IMPORTANT - FOR THE ATTENTION OF THE CHIEF ENGINEER

Dear Tektronix 2213/2215 Oscilloscope Customer:

MODIFICATION TO CRT HEATER TRANSFORMER

For the following TEKTRONIX oscilloscopes

FIG 1

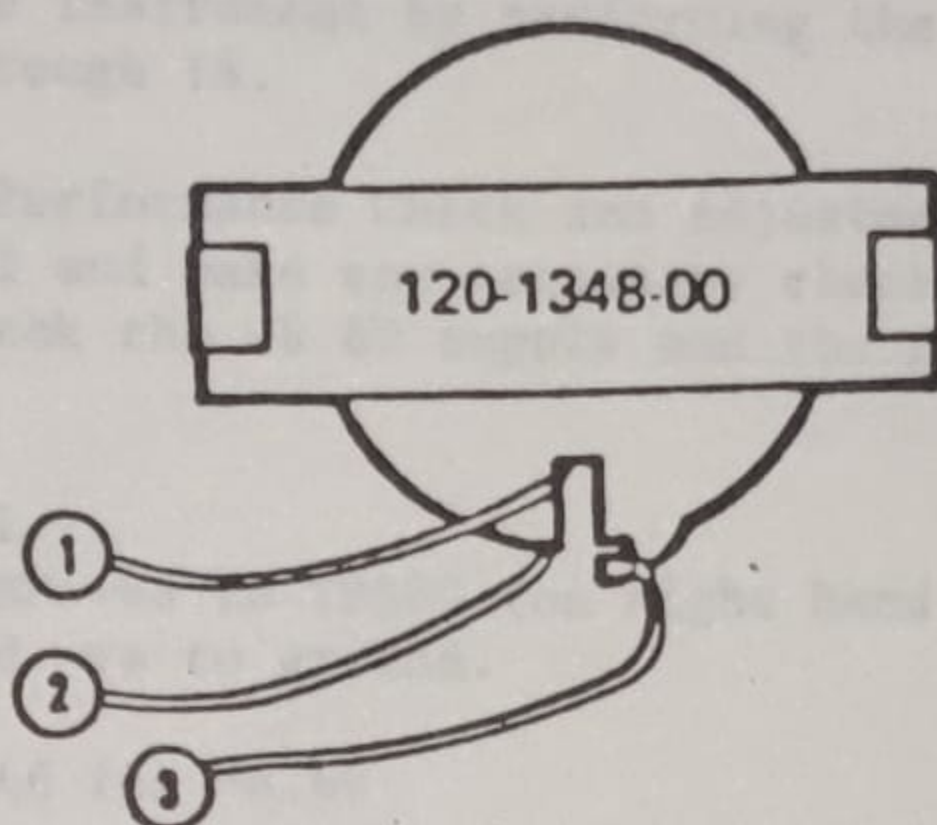
- () 17. Locate the lead of T940 labelled (3) in Fig. 1. Unsolder this lead from the Main circuit board, noting location for later reassembling.
- () 18. Unhook wire (3) from small retaining clip in transformer bobbin and unwind one complete turn. Refer to Fig. 2.
- () 19. Snap wire back into the retaining clip and pull tight.
- () 20. Cut off 3 inches of lead. Trim 3/16 inch insulation off remaining lead. Take care not to nick or cut the wires.
- () 21. Dress wire (3) back through the transformer core as indicated in Fig. 3.
- () 22. Tin the stripped lead and resolder it to the Main circuit board pad, noted previously. The dress of the wire is not critical except it should not be pulled tight against the edge of the transformer core.
